Trudeau Building Rehabilitation

Addendum #4: Historic Saranac Lake – Trudeau Building Rehabilitation
PROJECT LOCATION: Reconstruction at 118 Main Street, Saranac Lake, NY 12983

Issue Date: February 16th, 2023

ADDENDUM 04

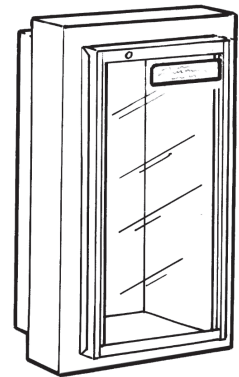
Q17: Requested additional information regarding fire extinguisher locations, baby changing stations and coat hooks.

A17: Fire extinguisher locations shall be as follows:

1. Foyer 107 on north side of partition between 107 and 107B.
2. Kitchenette 119 on east side of short partition wall at east end of countertop.
3. Hall 208 on east side of west wall between Opening 209C and Door 210A
4. Breakroom 201 on east wall north of Window E16.

All extinguishers shall be located within new semi-recessed cabinets with the exception of Room 201 where it shall be a wall mounted extinguisher without a cabinet. Cabinet basis of design is as follows: Semi-recessed cabinet, Model #: KF9732-C by Kidde Corporation of dimensions 9" wide x 24" tall x 6" deep to accommodate a 10 lb. dry chemical fire extinguisher. Cabinet specification sheet attached with highlighted model.

1 MECHANICAL CELLAR PLAN
 M1.0 SCALE: 1/4" = 1'-0"

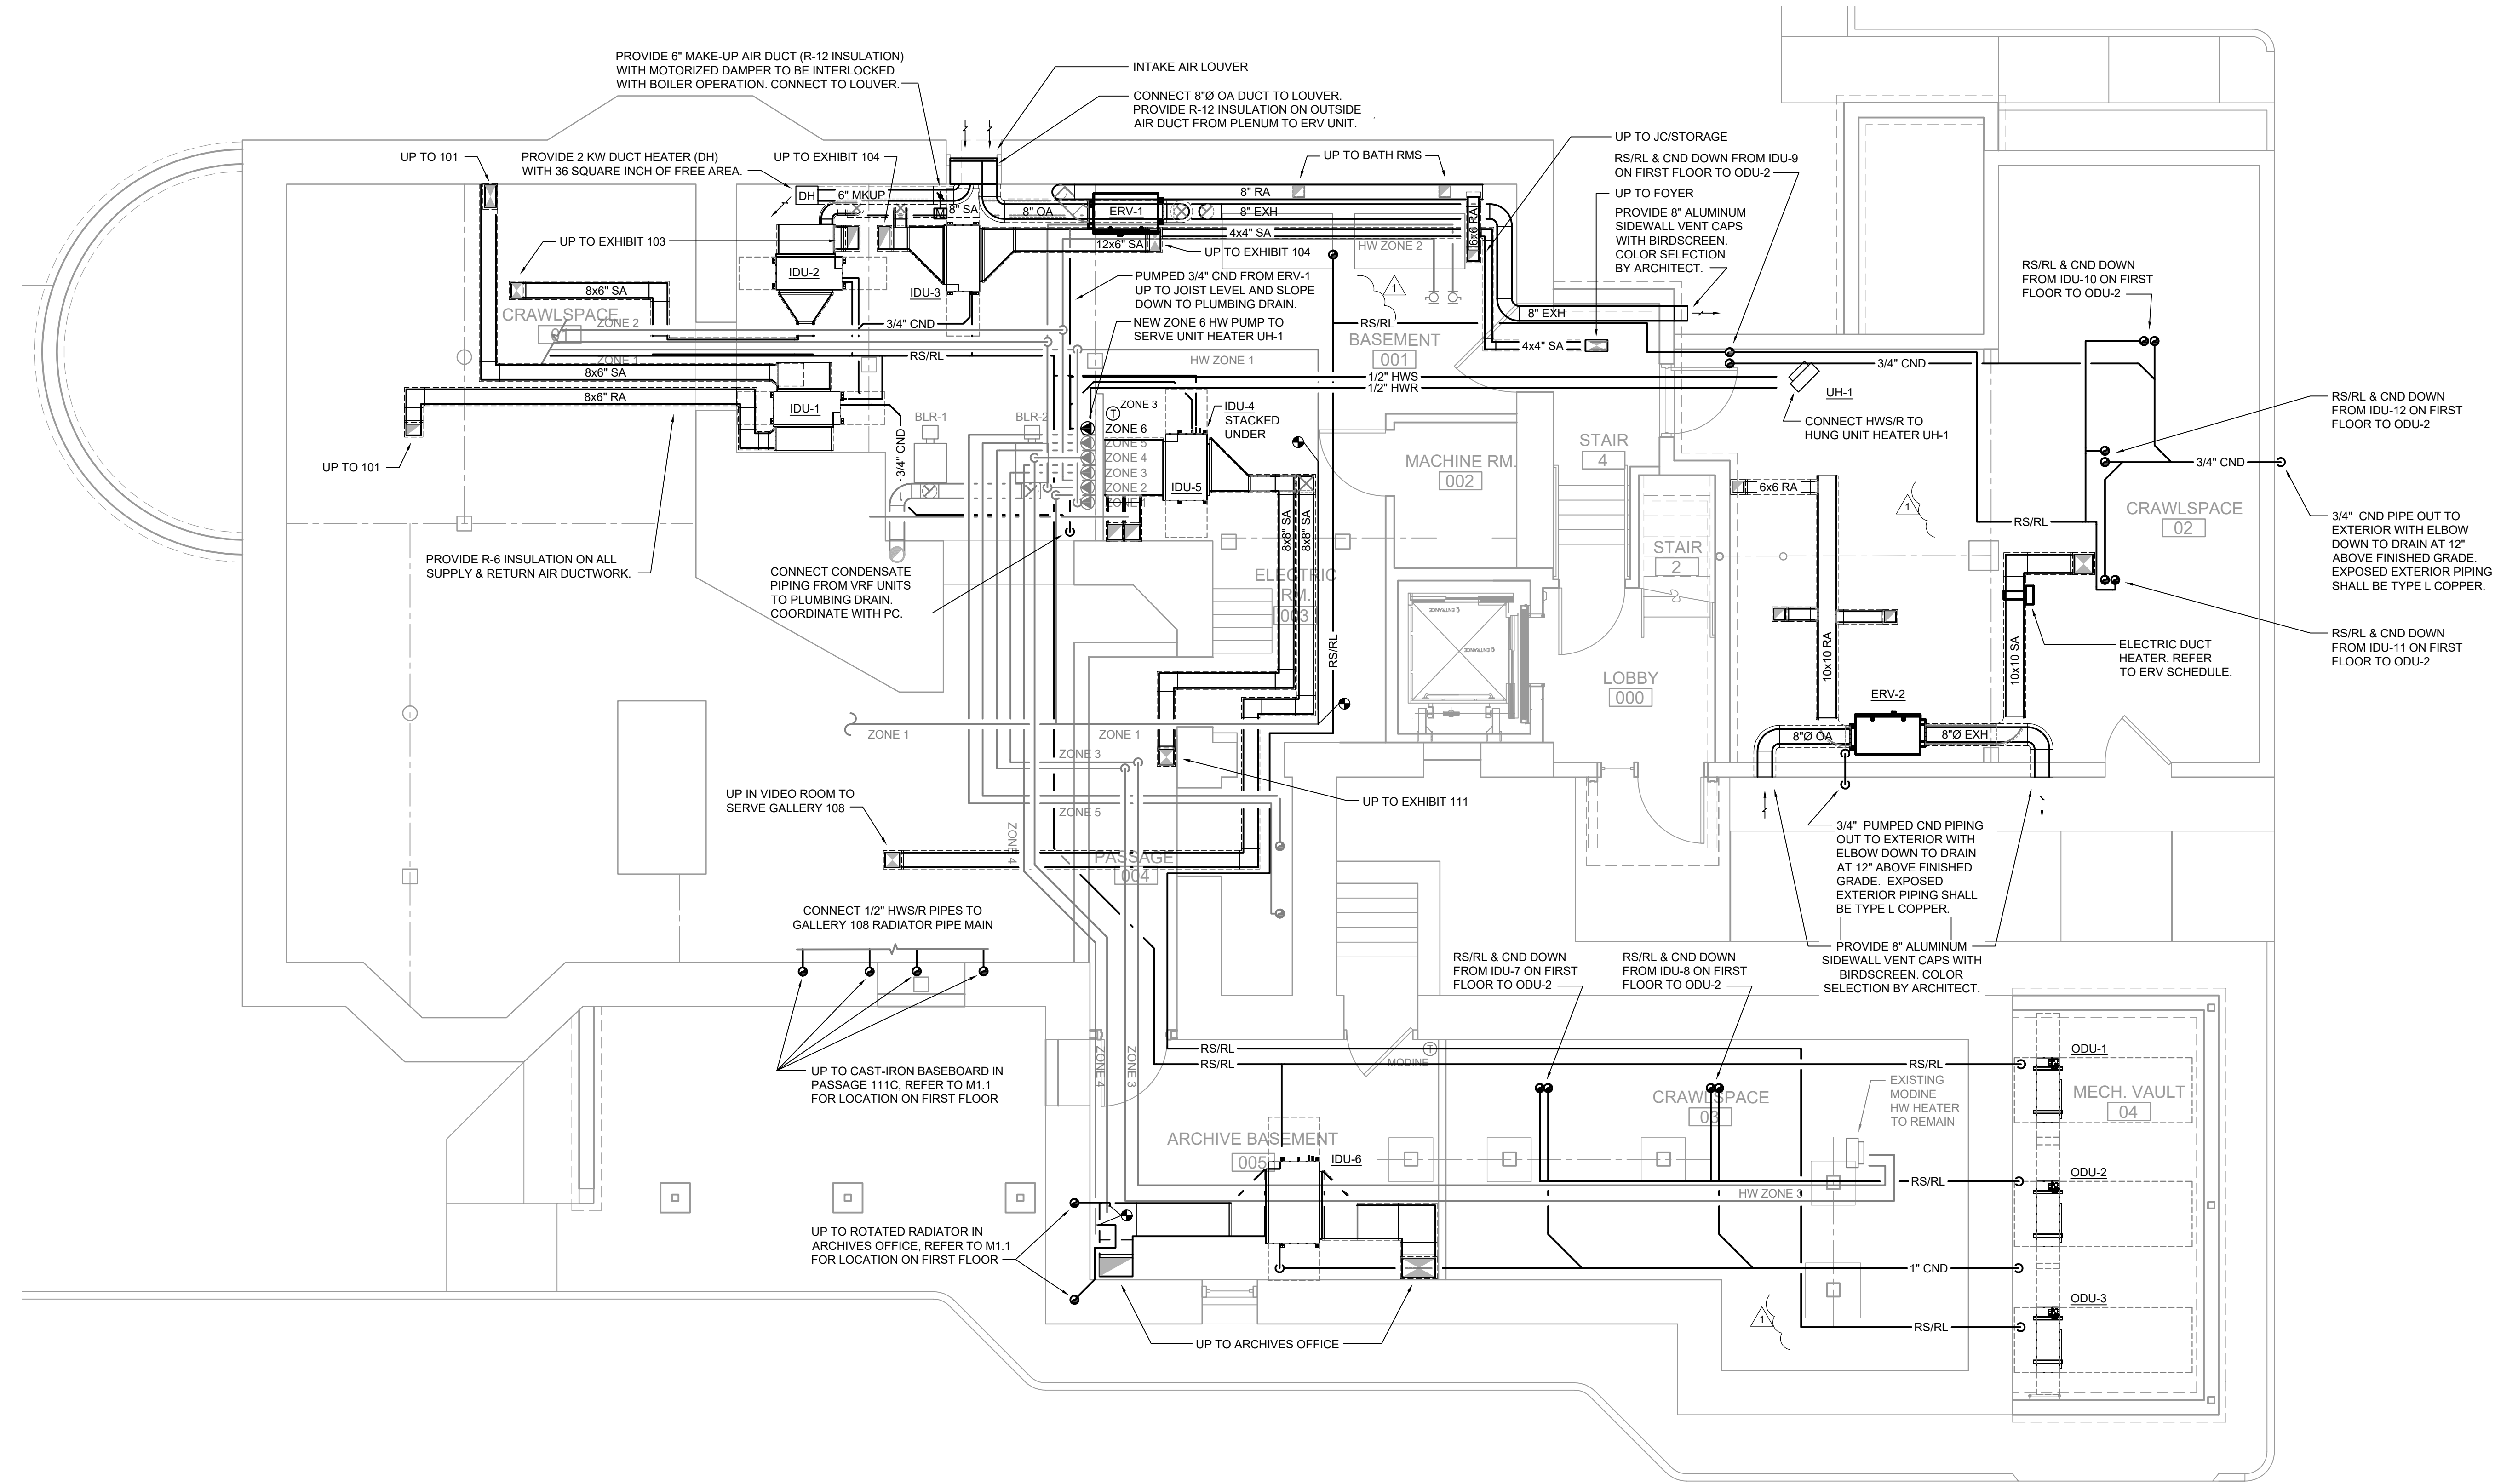
Q9: M1.0 illustrates ¾" hot water lines to new unit heater (new ZONE #6). M4.1 shows schematic of these same lines a ½". Please confirm what size is required?

Q10: Reference Drawing M1.0: Refrigeration lines leaving ODU-2 and ODU-3 in Mech Vault 04 (under South porch) (ARCHIVAL WING) are illustrated heading east to CRAWLSPACE 02 (TENANT WING).... What is the plan for this approach? You have nothing noted or detailed for these lines. Buried or above grade? Please provide clarification and construction details.

A9: The heating pipes serving zone 6 (UH-1) shall be ½", not ¾".

A10: The refrigeration lines running between the tenant wing Crawl Space 02 and Mech vault 04 shall be run through the basement. They shall not run in a trench or a sleeve.

1. The heating pipes serving zone 6 (UH-1) shall be ½", not ¾".
2. The refrigeration lines running between the tenant wing Crawl Space 02 and MECH vault 04 shall be run through the basement. They shall not run in a trench or a sleeve. main
